STATE OF MAINE
DEPARTMENT OF TRANSPORTATION
16 STATE HOUSE STATION
AUGUSTA, MAINE
04333-0016

May 18, 2009
Subject: **Charleston**
State Project No. 015093.00
State Pin No. 015093.00
Amendment No. 3

STATE OF MAINE DEPARTMENT OF TRANSPORTATION BR-1509(300)X PIN 15093.00		BRIDGE NO. 2196				DATE: 3/13/09 P.E. NUMBER: 4226 SIGNATURE: <i>[Signature]</i>		FIELD CHANGES: REVISIONS 4 REVISIONS 3 REVISIONS 2 REVISIONS 1		INTERSECTION IMPROVEMENT PLAN CHARLESTON PENOBSCOT COUNTY CREAMERY BRIDGE ROLLINS BROOK		SHEET NUMBER 16 OF 18	
STATE OF MAINE DEPARTMENT OF TRANSPORTATION		BRIDGE NO. 2196				DATE: 3/13/09 P.E. NUMBER: 4226 SIGNATURE: <i>[Signature]</i>		FIELD CHANGES: REVISIONS 4 REVISIONS 3 REVISIONS 2 REVISIONS 1		INTERSECTION IMPROVEMENT PLAN CHARLESTON PENOBSCOT COUNTY CREAMERY BRIDGE ROLLINS BROOK		SHEET NUMBER 16 OF 18

SPECIAL PROVISION
SECTION 403
HOT MIX ASPHALT

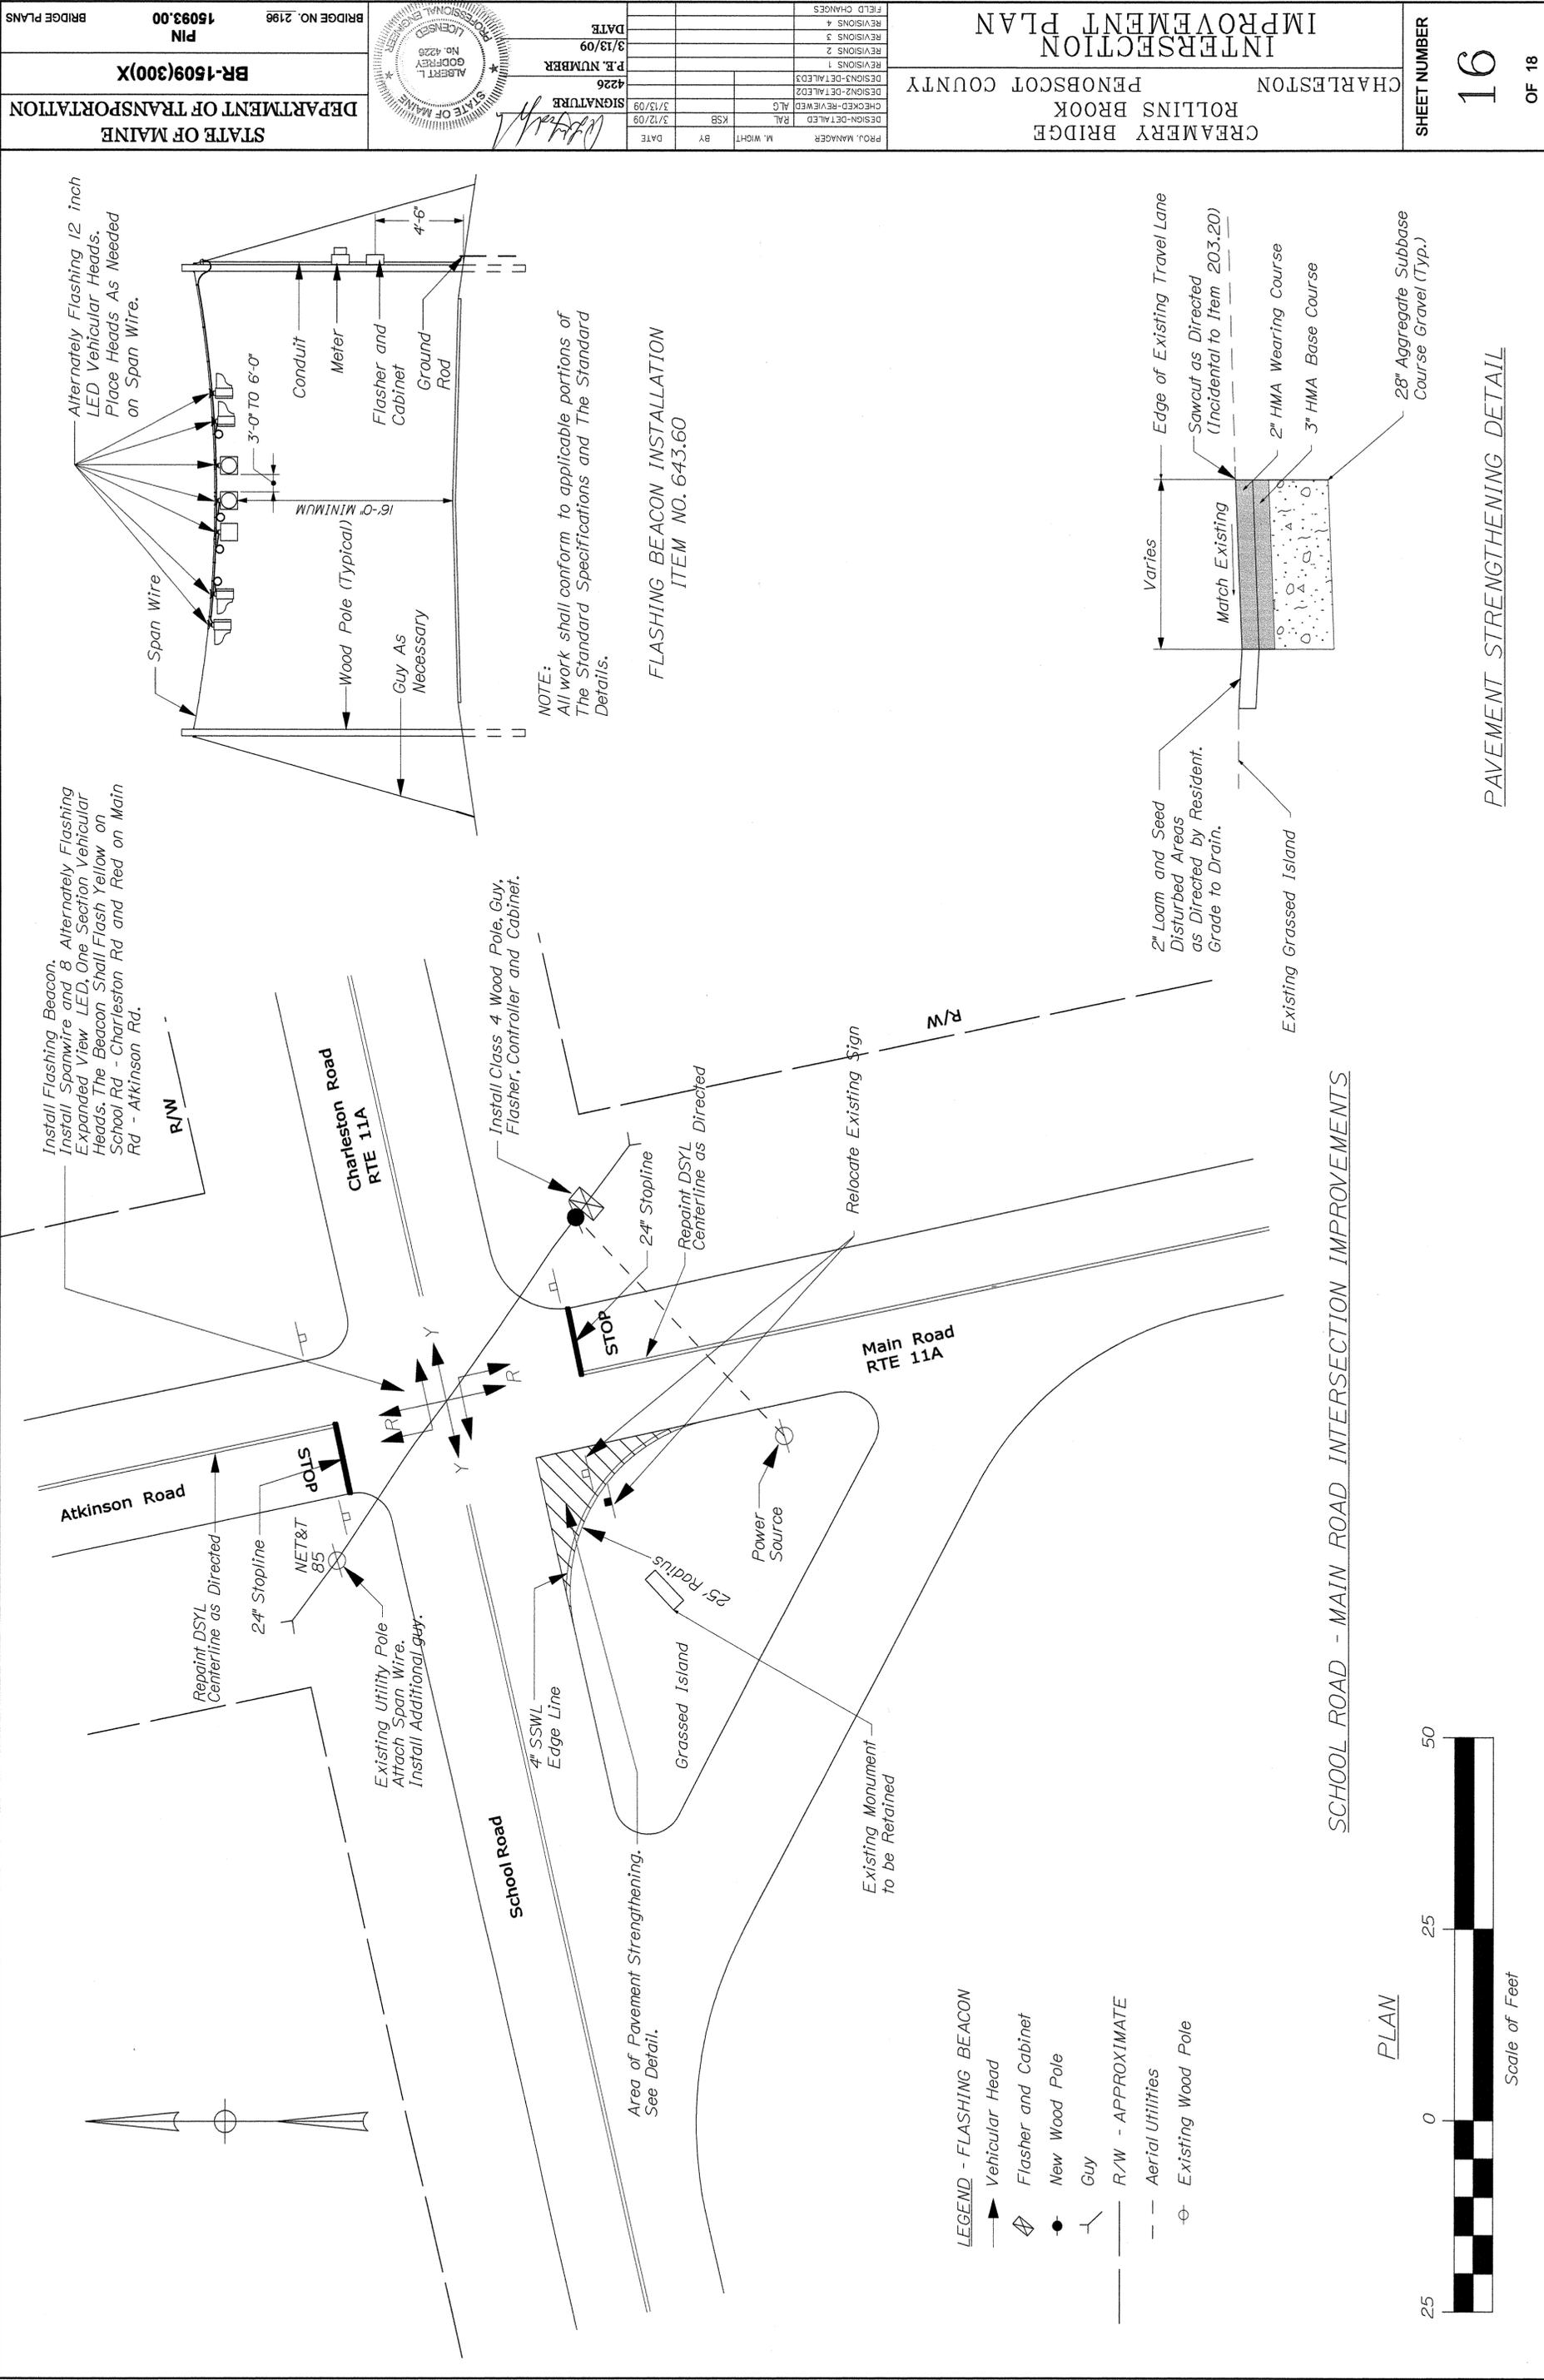
In the Bid Book (page 62), **REMOVE** "SPECIAL PROVISION, SECTION 403, HOT MIX ASPHALT" 1 page dated March 27, 2009 and **REPLACE** it with the attached new "SPECIAL PROVISION, SECTION 403, HOT MIX ASPHALT" 1 page dated May 14, 2009.

SCHOOL ROAD - MAIN ROAD INTERSECTION IMPROVEMENTS

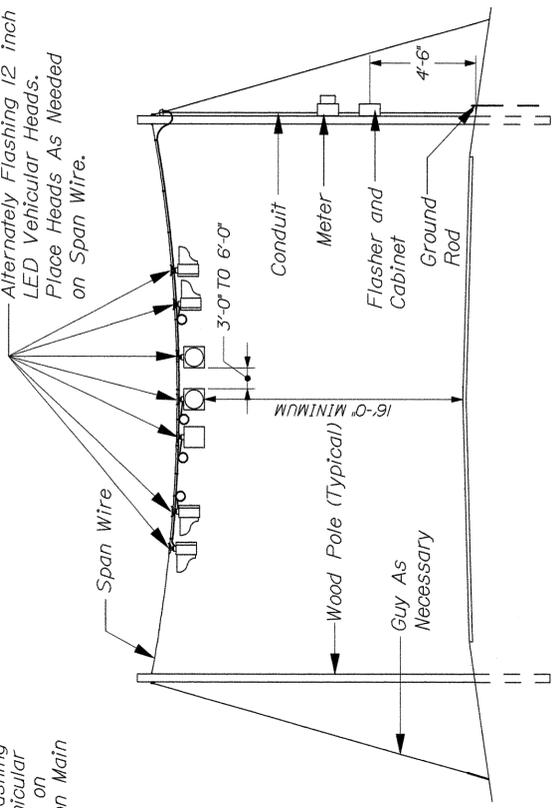
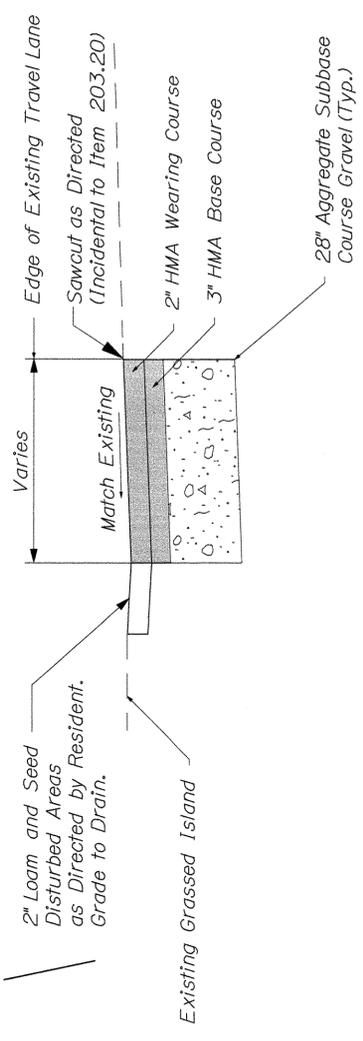
Question: Plan Sheet 16 calls for intersection improvements at School Road and Main Road which includes the Beacon and shows an earth work section. What is the extent of the paving and earth work at this intersection?

Response: Please refer to the updated sheet 16.

Install Flashing Beacon.
Install Spanwire and 8 Alternately Flashing Expanded View LED. One Section Vehicular Heads. The Beacon Shall Flash Yellow on School Rd - Charleston Rd and Red on Main Rd - Atkinson Rd.
